**PLANNING COMMISSION AGENDA
SEPTEMBER 19, 2019 – 6:30 P.M.**

**Planned Unit Development (PUD)—
Brixmor Property Group, LLC**

RE: Planned Unit Development (PUD) Amendment
Initial Review
Brixmor North – Southport West

Comment Response: PUD Brixmor North

drawn by: JLC
 checked by: EW
 approved by: .
 QA/CC by: .
 project no.: 019-1124
 drawing no.: 06.03.19
 date: 06.03.19
 SHEET C4.1

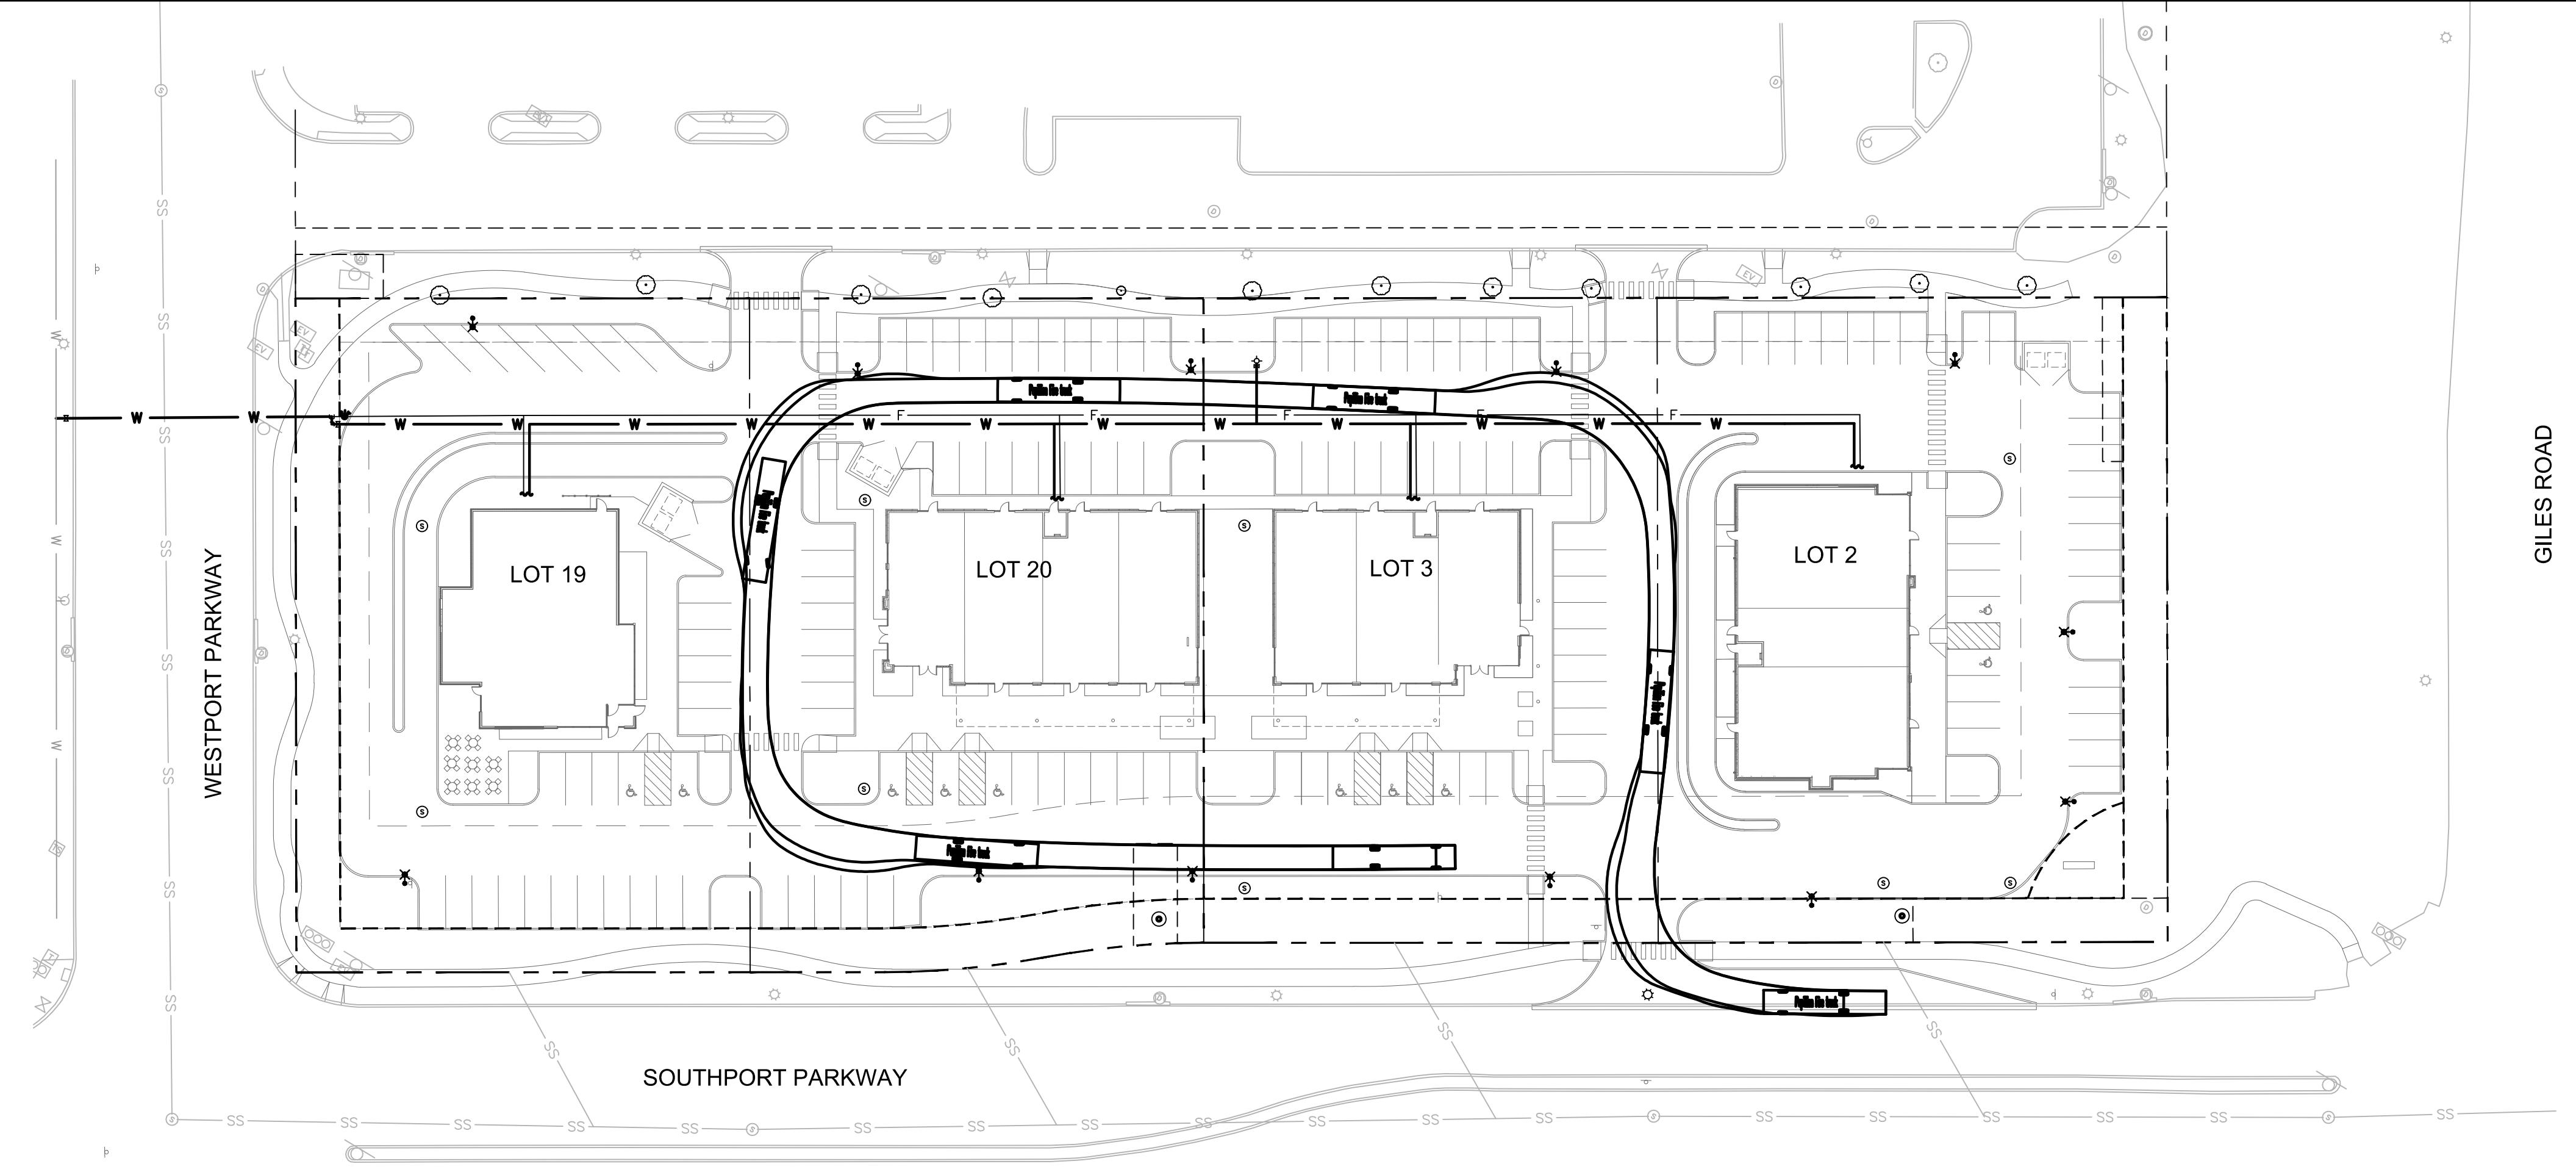
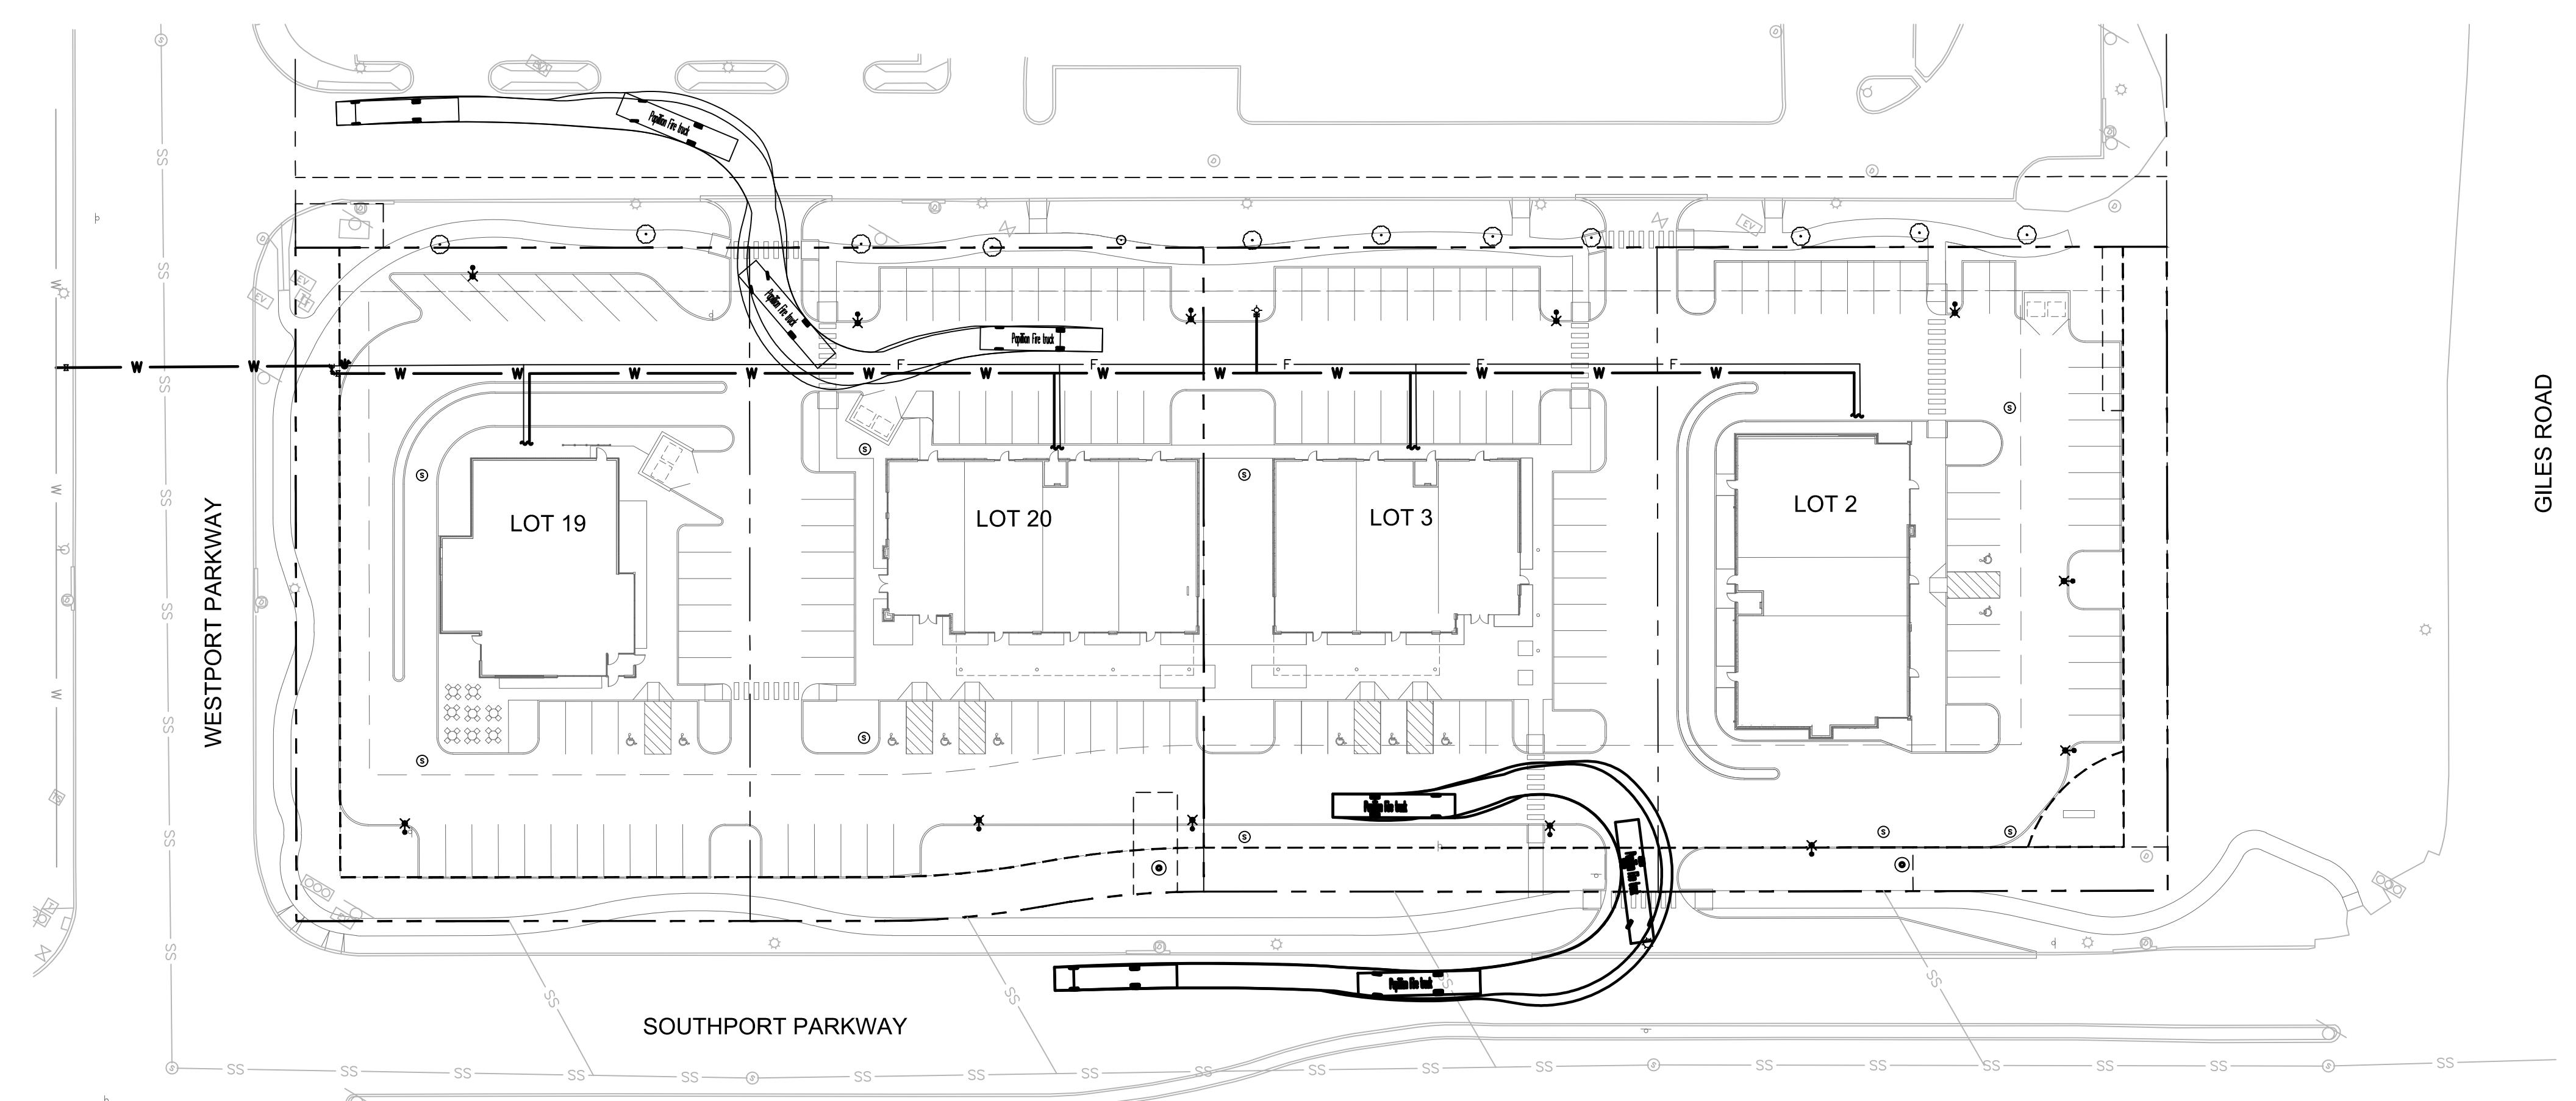
- Please confirm that the water main on the hotel lot proposed for connection is a public water main.
- The proposed sanitary sewer is running against the topography to reach Westport Parkway. There may be stub outs in Southport Parkway that could be able to serve the lots.
- PCSMP Plan will need to be reference to this drawing as well.
- If the existing storm sewer at the northeasterly side of Lot 2 is outside of the 15 ft easement as it is shown, additional easement will be required.

SHEET
C5.1

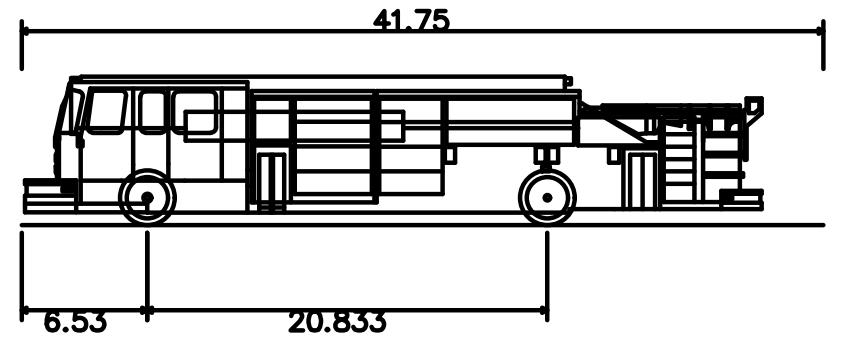
- In the Emergency Vehicle Access Plan, the proper apparatus turning radii and proper vehicle size were not used. The proper apparatus, provided by the Fire Marshall, is attached. Please adjust the turns and display the proper basis/legend in the top-right corner.

**SHEET
L1.1**

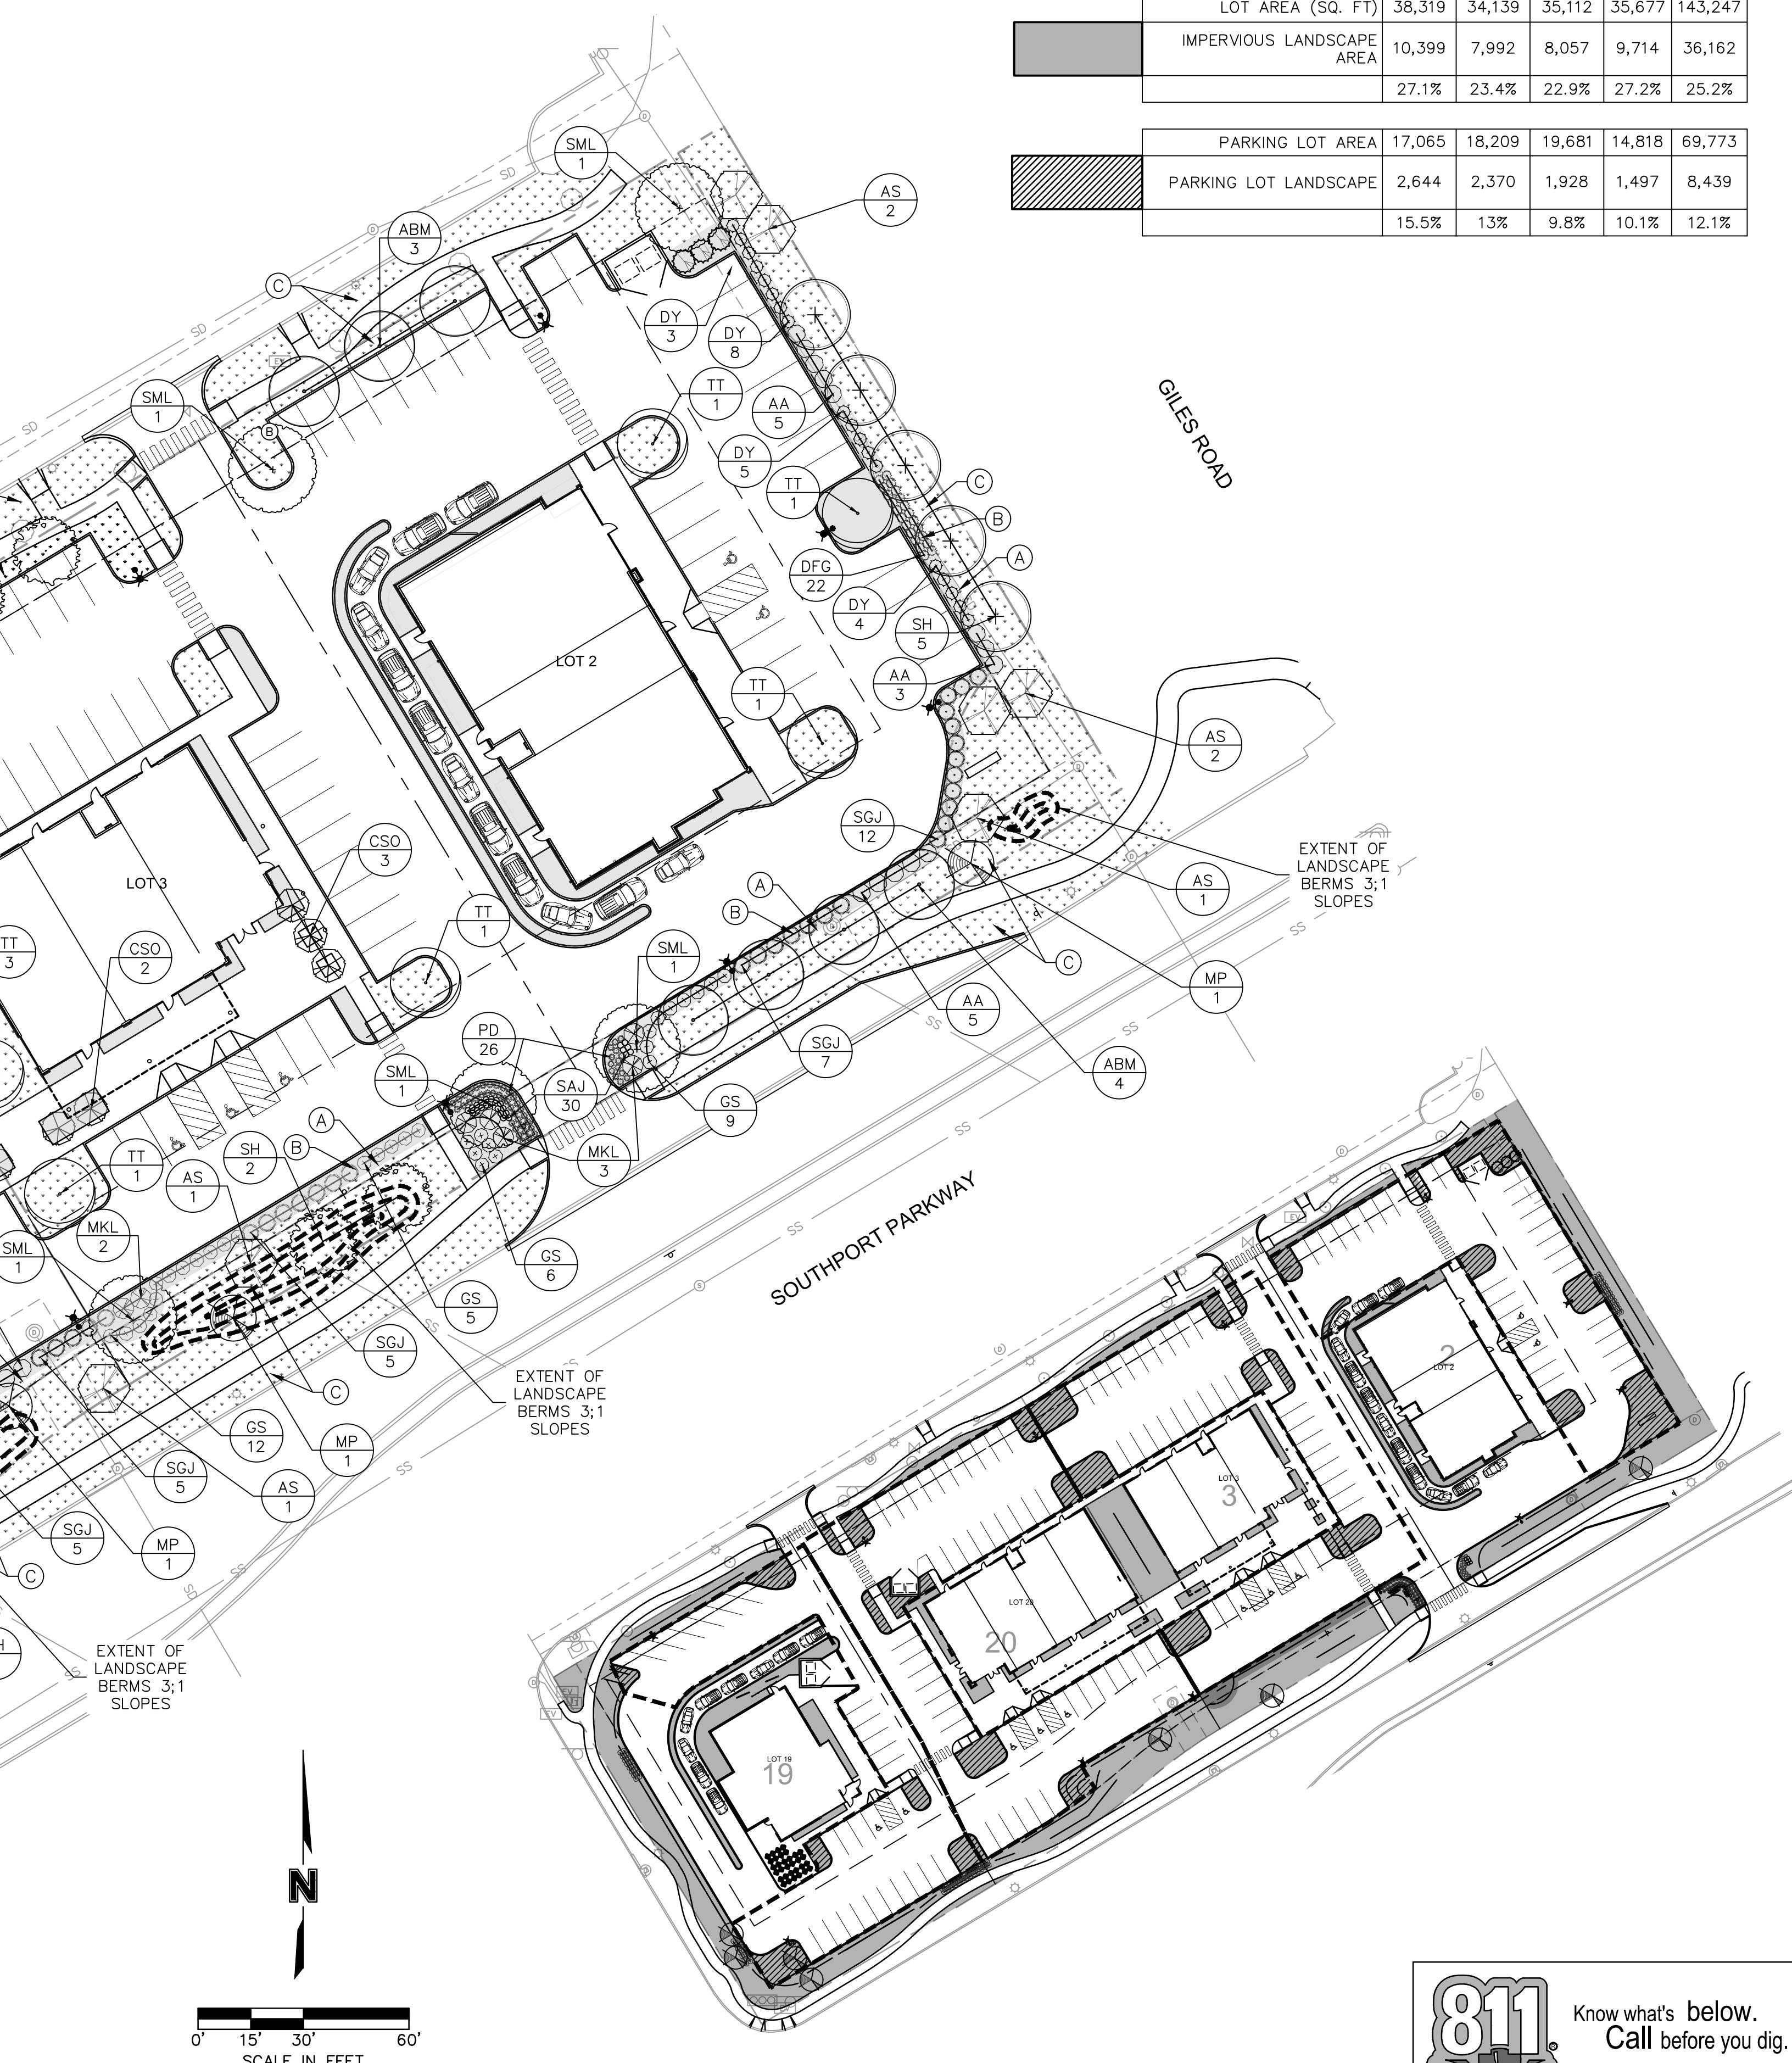
- Proposed berthing not in conformance with regulations. See comments regarding Sheet C3.1 for more information.
- The dumpster location in the northeast corner of the property needs to be moved away from the Giles Road frontage.

- Proposed berthing not in conformance with regulations. See *comments* regarding Sheet C3.1 for more information. **Response: Berming has been revised to meet the requirements provided in Appendix C.**
- The dumpster location in the northeast corner of the property needs to be moved away from the Giles Road frontage. **Response: Dumpster has been relocated to the north parking area. This has been placed outside of the easement and the site plan has been updated.**

Figure 2. Existing Traffic Volumes

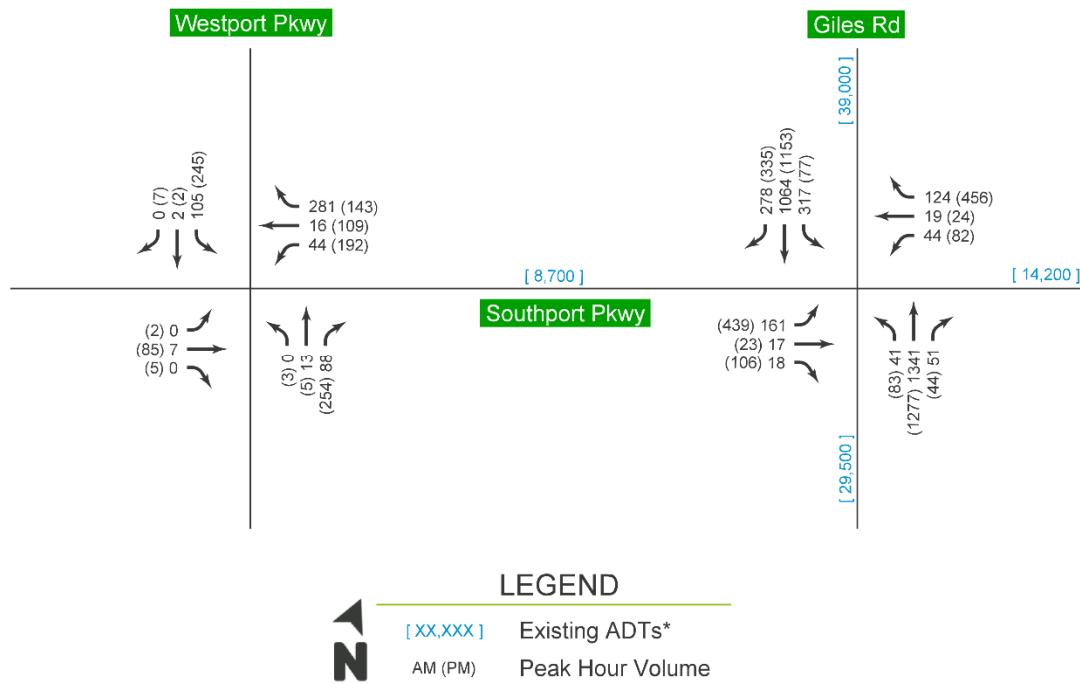
- Please note the source of Existing ADT values in Figure 2 of the study.
- Please provide total driveway volumes when considering both primary and pass-by trips.
- Trip distribution does not appear to fully take into account pass by trips to destinations within Southport development. Is there a standard methodology that is being used to apply the distribution percentages as applicable adjacent land uses/trip generators?
